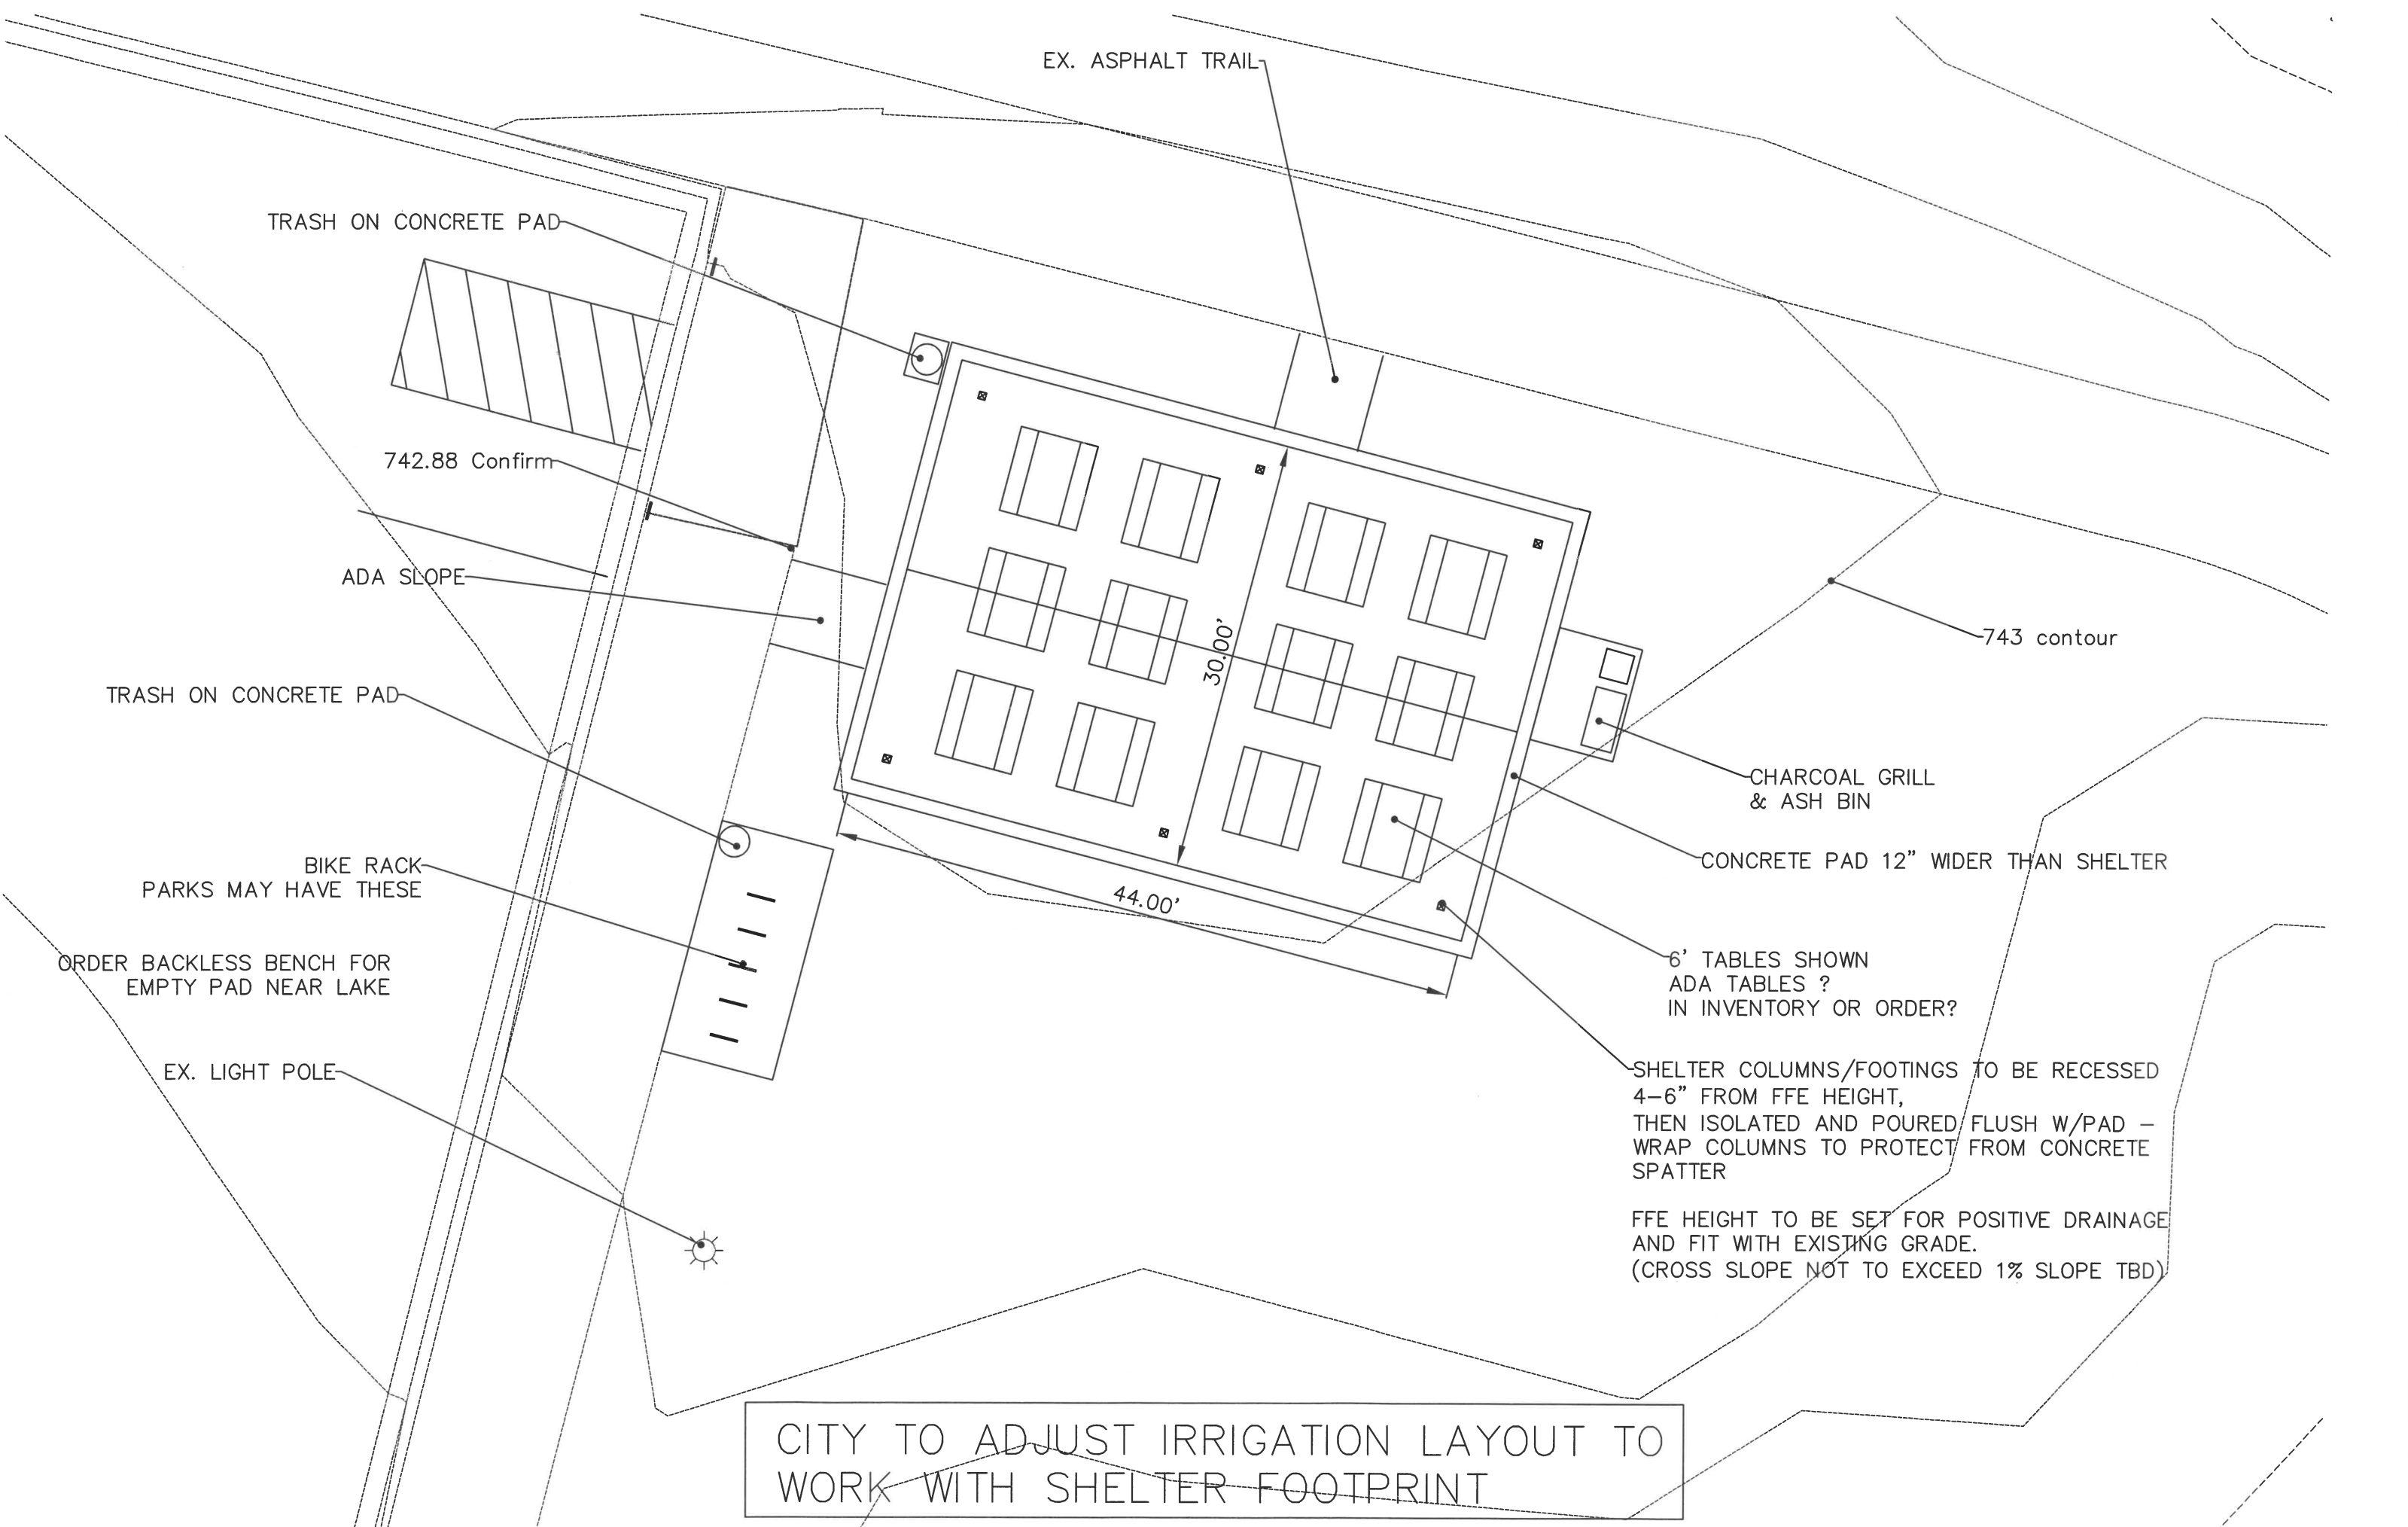
742.88 Confirm

ADA SLOPE

BIKE RACK
PARKS MAY HAVE THESE

ORDER BACKLESS BENCH FOR
EMPTY PAD NEAR LAKE

743 contour

CONCRETE PAD 12" WIDER THAN SHELTER

6' TABLES SHOWN
ADA TABLES ?
IN INVENTORY OR ORDER?

SHELTER COLUMNS/FOOTINGS TO BE RECESSED
4-6" FROM FFE HEIGHT,
THEN ISOLATED AND POURED FLUSH W/PAD -
WRAP COLUMNS TO PROTECT FROM CONCRETE
SPATTER

FFE HEIGHT TO BE SET FOR POSITIVE DRAINAGE
AND FIT WITH EXISTING GRADE.
(CROSS SLOPE NOT TO EXCEED 1% SLOPE TBD)

CITY TO ADJUST IRRIGATION LAYOUT TO
WORK WITH SHELTER FOOTPRINT
